STAFF RECOMMENDATION
1825 4th Avenue North
July 20, 2016

Application: New construction—addition
District: Salemtown Neighborhood Conservation Zoning Overlay
Council District: 19
Map and Parcel Number: 08108029400
Applicant: Kyle Keaffaber & Raj Gummi
Project Lead: Melissa Baldock, melissa.baldock@nashville.gov

Recommendation Summary: Staff recommends disapproval of the proposed addition, finding that its scale is too large for the historic house and that the cladding material, lack of corner boards, and fenestration patter do not meet the design guidelines. Staff finds that the proposed addition does not meet the following sections of the Salemtown Neighborhood Conservation Zoning Overlay design guidelines: Sections III.B. (for massing), III.D. (for materials), III.G. (for proportion and rhythm of openings), IV.B. (for addition massing), and IV.G. (for an addition following the design guidelines for new construction).

Figure 2 (left) is the existing rear porch and Figure 3 (right) is the 1951 Sanborn Map showing a similar porch in location and scale.

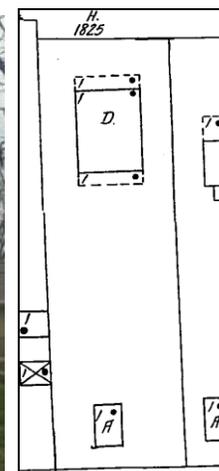
Partial Demolition: The applicant is proposing to remove a covered porch at the rear of the house (Figure 2). Although the covered porch seems to be shown on the 1951 Sanborn map (Figure 3), staff finds that it does not contribute to the overall historic character of the house and that its removal will not affect the house's historic integrity.

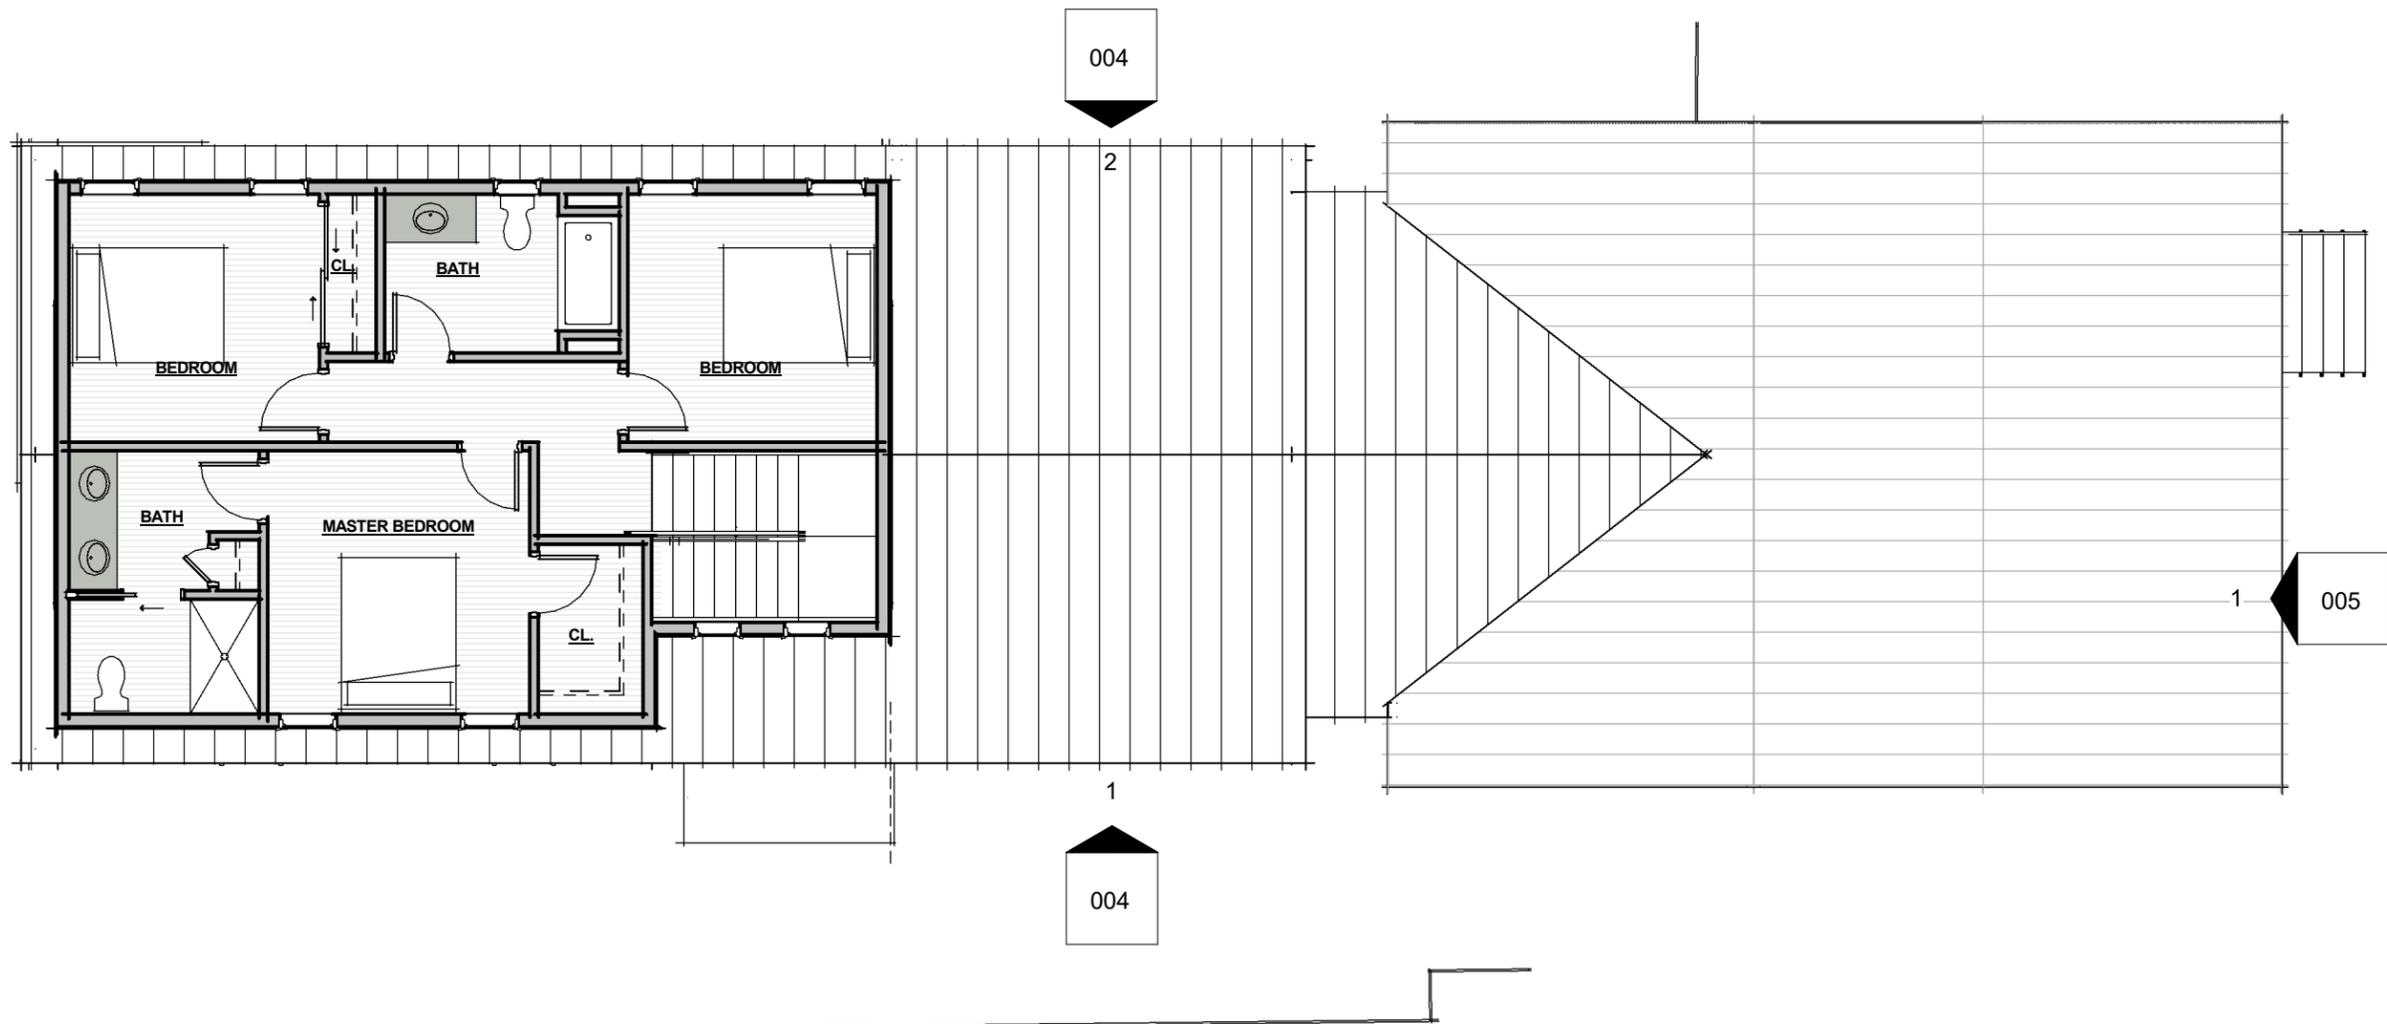
Staff finds that the addition’s proposed scale overwhelms the historic house. Although it is just a few inches taller than the historic house, its depth and volume result in an addition that is not sufficiently subordinate to the historic house. The addition more than doubles the footprint of historic house. The addition will have a footprint that is approximately two hundred and sixty-three square feet (263 sq. ft.) larger than the existing historic house (including the existing addition that will be removed). With this proposed project, the house’s total footprint would be increased from approximately one thousand, one hundred and seventy-nine square feet (1,170 sq. ft.) to two thousand, six hundred and twenty-one square feet (2,621 sq. ft.).

The addition’s out-of-scale footprint is compounded by the fact that the addition is slightly taller than the historic house, and has a one-and-a-half story form attached to a one-story historic house. The footprint, height, and one-and-a-half story form together create an addition that is too large for the historic house.

Staff finds that the proposed addition’s scale does not meet Sections III.B. and IV. B. of the design guidelines.

WEST ELEVATION - PRES

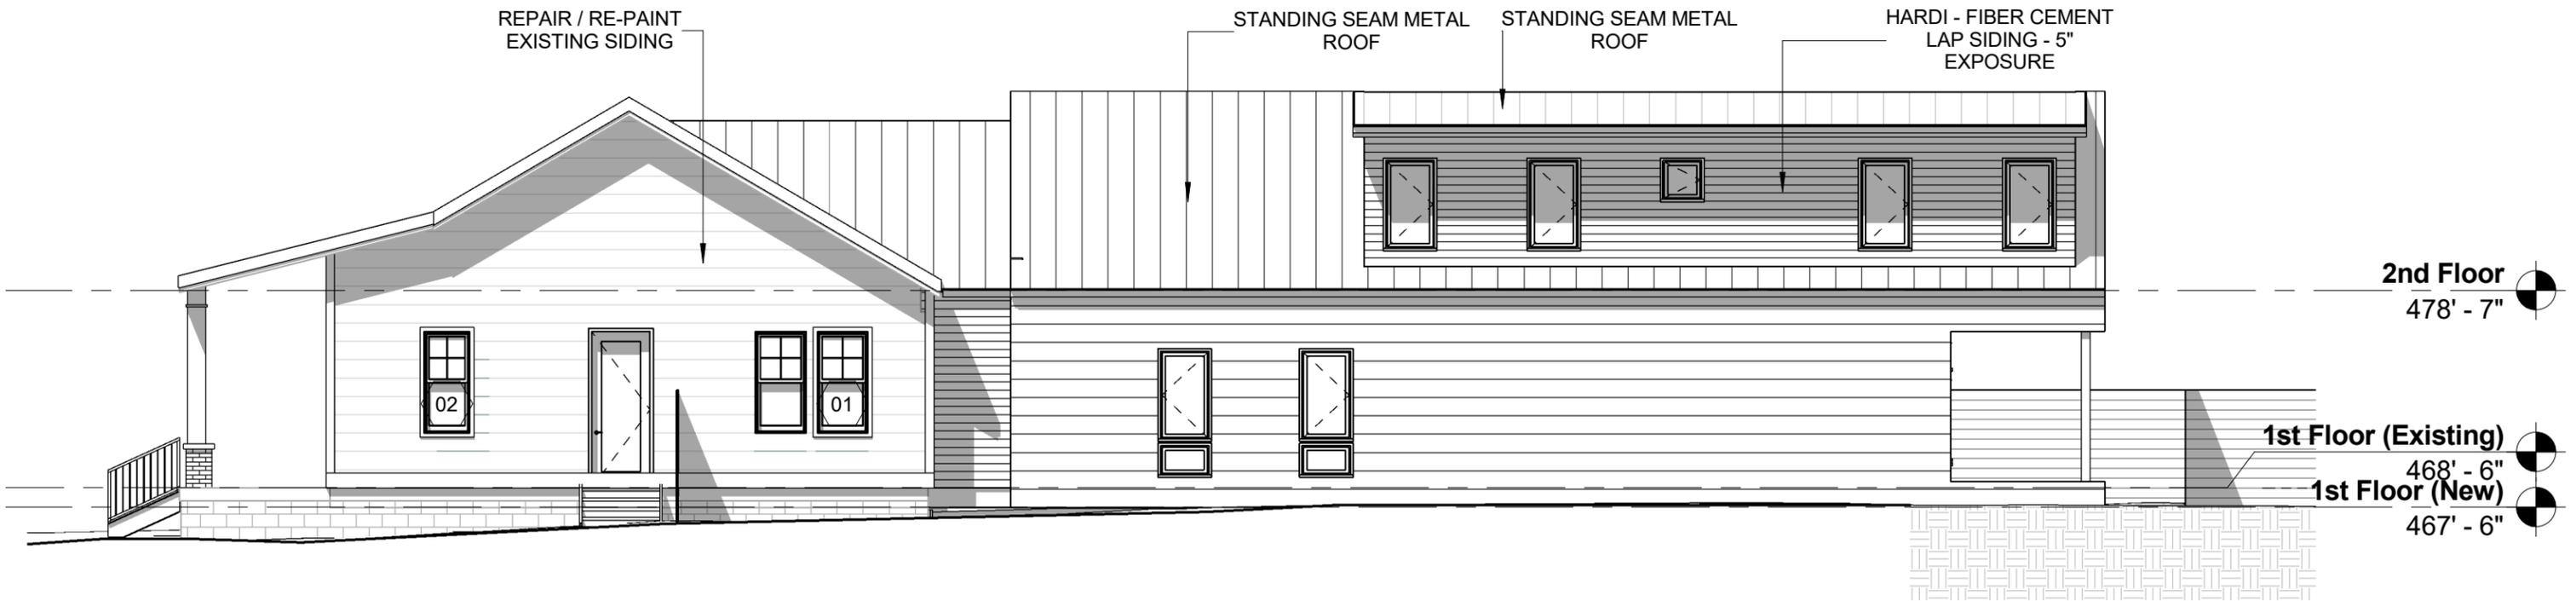
On the west/right elevation, there is an expanse of thirty feet, six inches (30’6”) without a wall and door opening. In the past, the MHZC has required a window opening approximately every eight to thirteen feet (8’-13’), although more leniency has been granted on side facades, towards the rear. In this case, the proposed expanse without a window or door opening is more than double the recommended amount. Staff finds that

the thirty-foot (30') expanse without a window or door opening is not appropriate because it is so large. Staff therefore finds that the addition's fenestration pattern does not meet Sections III.G. and IV. G. of the design guidelines.
